**SB-10056824-7070**

## Client Satisfaction Improvement Campaign: Update for 2015 MDX and TLX ODMD (Vehicles with Navigation)

# Software Improvements for Your 2015 MDX

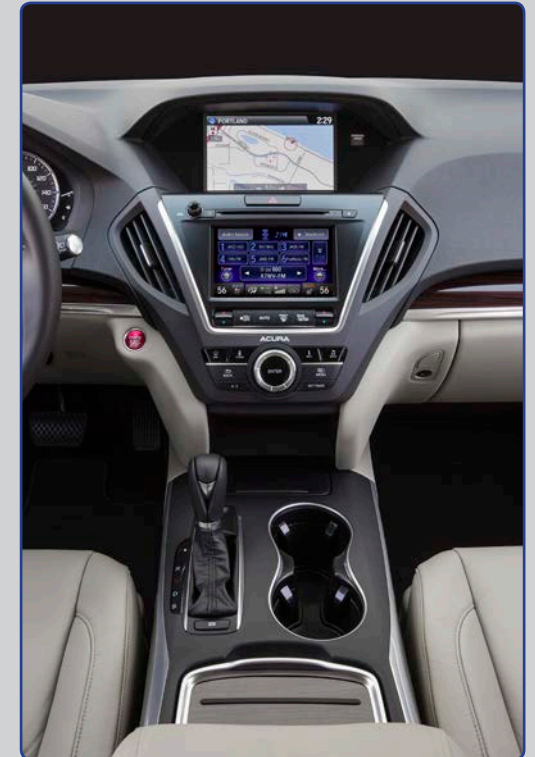
## Audio improvements

When playing FM, AM, or SiriusXM® radio, tune to stations directly from the ODMD preset screen.

Artist and track information is viewable, when available, on both the main ODMD screen and preset screen.

Basic audio functions (such as scan, random, repeat, sound settings, etc.) can be selected from the main ODMD screen.

Customize audio sources on the ODMD screen in the order you want using the Edit Order option in the Audio Source screen.

From the voice portal, you can say the full destination address. Press the Talk button, say "Address," and follow the prompts.

Free-flow traffic is a brighter green, which is easier to see on the map.

Adjust the guidance volume during guidance using the steering wheel volume dial or audio volume knob.

Helpful prompts appear during the phone pairing process.

# Software Improvements for Your 2015 TLX

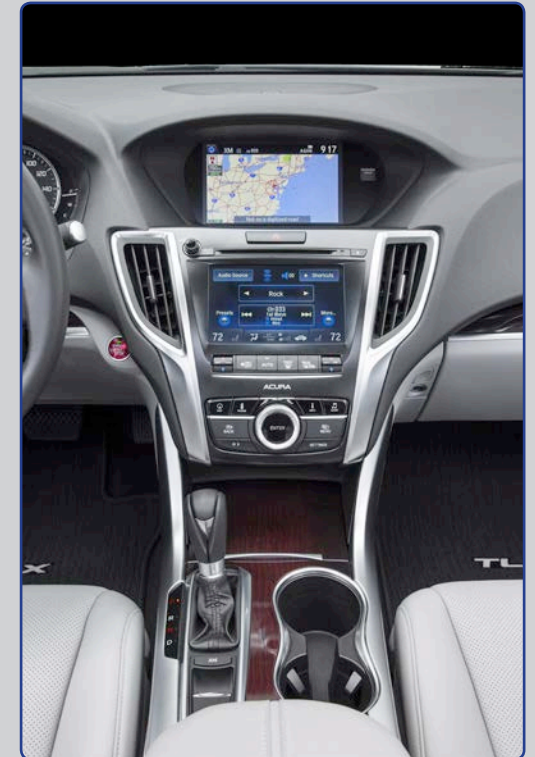
## Audio improvements

When playing FM, AM, or SiriusXM® radio, tune to stations directly from the ODMD preset screen.

Artist and track information is viewable, when available, on both the main ODMD screen and preset screen.

Basic audio functions (such as scan, random, repeat, sound settings, etc.) can be selected from the main ODMD screen.

Customize audio sources on the ODMD screen in the order you want using the Edit Order option in the Audio Source screen.

Adjust the guidance volume during guidance using the steering wheel volume dial or audio volume knob.

Helpful prompts appear during the phone pairing process.
